Formosa Plastics

RE: EPA Request for Information
Greenhouse Gas Permit Application
Formosa Plastics Corporation, Texas
2012 Expansion Project: LDPE Plant
Point Comfort, Calhoun County, Texas

Attachment

LDPE Flare Header - Simplified Flow Diagram

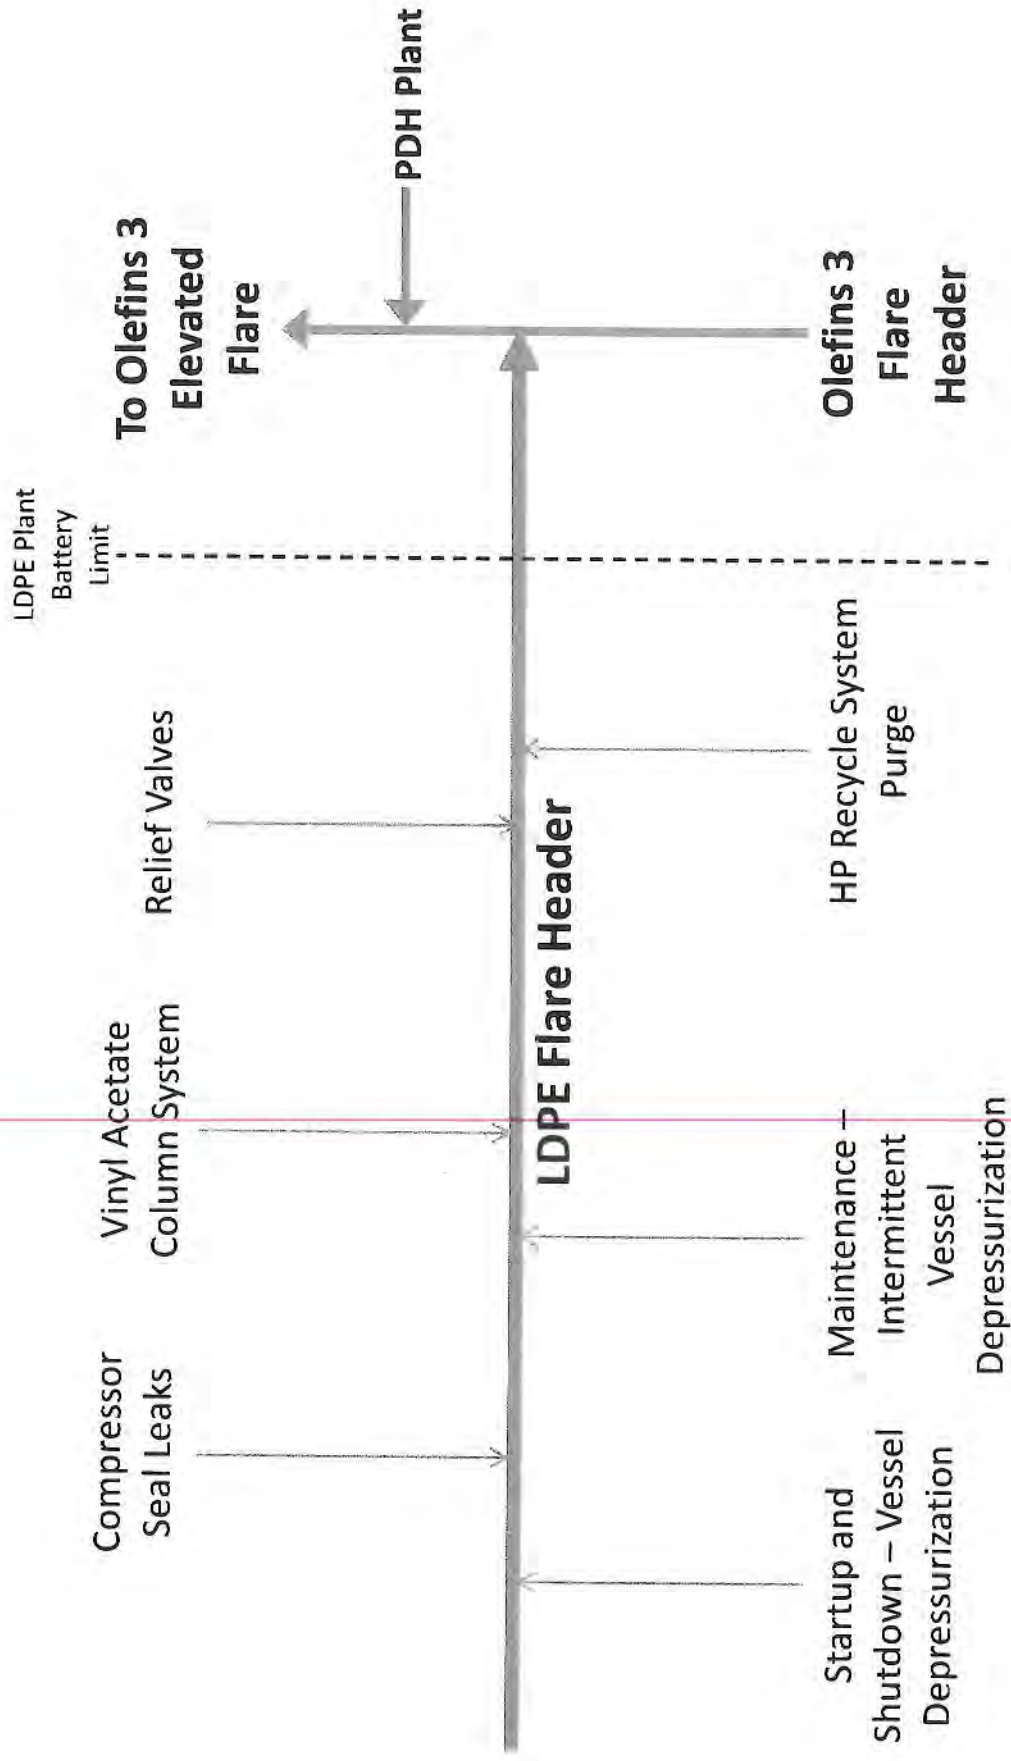
6. ***On page 23 of the permit application, it is stated that "normal" emission sources from the LDPE process upstream of and including the extruder are routed to the LDPE flare header. Also, there are several flare header connections in the compression and reaction systems. The LDPE plant's flare gas header is routed to the Olefins 3 elevated flare header where the waste gas from LDPE plant is combusted along with waste gas from the Olefins 3 process.***

Please supplement the process flow diagram to show the LDPE flare header and its path to the Olefins 3 elevated flare header.

FPC TX Response: All major equipment routed to the LDPE flare header are identified on a separate LDPE flare header flow diagram (attached). This flow diagram is intended to provide information about the types of equipment and connections that are designed to be vented to the flare. This simplified diagram does not show each discrete physical connection to the LDPE flare header that would be provided in final confidential engineering design drawings.
